Access Compliance Report

Public Rights-of-Way

(Curb Ramps)

Intersection ID: 4194	Main Street: COLVARD_PARK_WY	Cross Street: MALLARD_CREEK_RD	Location: NW
ADA ID: 7DC0445B3EBF	Ramp Type: Perp	Initial Pass/Fail: Fail	Overall Compliance: No
Severity Score: 33.75			
Codes/Mitigation Info/Possible Solution		Field Measurements/Component Compliance

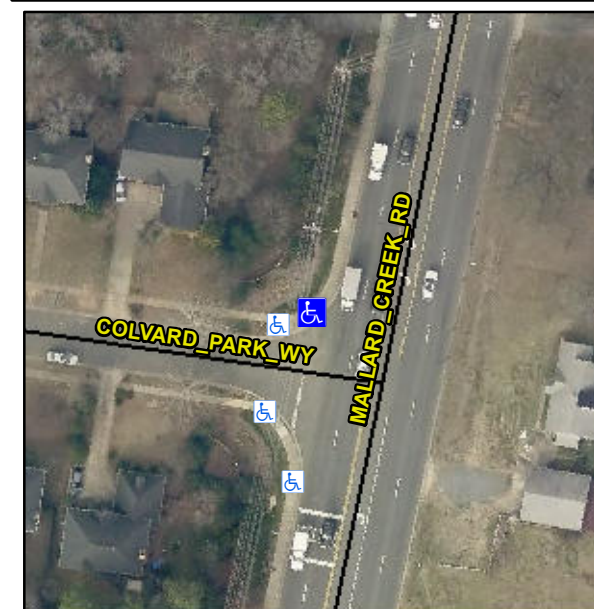
R304.5.1, R304.2.2

Compliance	Description	Data	Compliance	Description	Data
N/A	Ramp Length (in)	61.5	No	Ramp Slope (%)	13.0
No	Ramp Width (in)	43.0	Yes	Ramp XSlope (%)	1.7
N/A	Flare Type LT	N/A	N/A	Flare Type RT	N/A
N/A	Flare Slope LT (%)	N/A	N/A	Flare Slope RT (%)	N/A
N/A	Flare Traversable LT?	N/A	N/A	Flare Traversable RT?	N/A
N/A	Landing Length (in)	N/A	N/A	DWS Provided?	N/A
N/A	Landing Width (in)	N/A	N/A	DWS Contrast?	N/A
N/A	Landing Slope (%)	N/A	N/A	DWS Length (in)	N/A
N/A	Landing X Slope (%)	N/A	N/A	DWS Full Width?	N/A
N/A	Landing Curb? (Y/N)	N/A	N/A	DWS Offset (in)	N/A
N/A	Shared Landing?	N/A			
N/A	Gutter Ponding?	N/A	N/A	Gutter Slope (%)	N/A
N/A	Gutter Lip Ht (in)	N/A	N/A	Gutter X Slope (%)	N/A
N/A	Painted X Walk1?	No	N/A	Painted X Walk2?	N/A
	X Walk 1 Direction	To E		X Walk 2 Direction	N/A
N/A	X Walk 1 Width (in)	N/A	N/A	X Walk 2 Width (in)	N/A
	X Walk 1 Slope (%)	0.3		X Walk 2 Slope (%)	N/A
	X Walk 1 X Slope (%)	1.4		X Walk 2 X Slope (%)	N/A

Remove & Replace Entire Ramp.
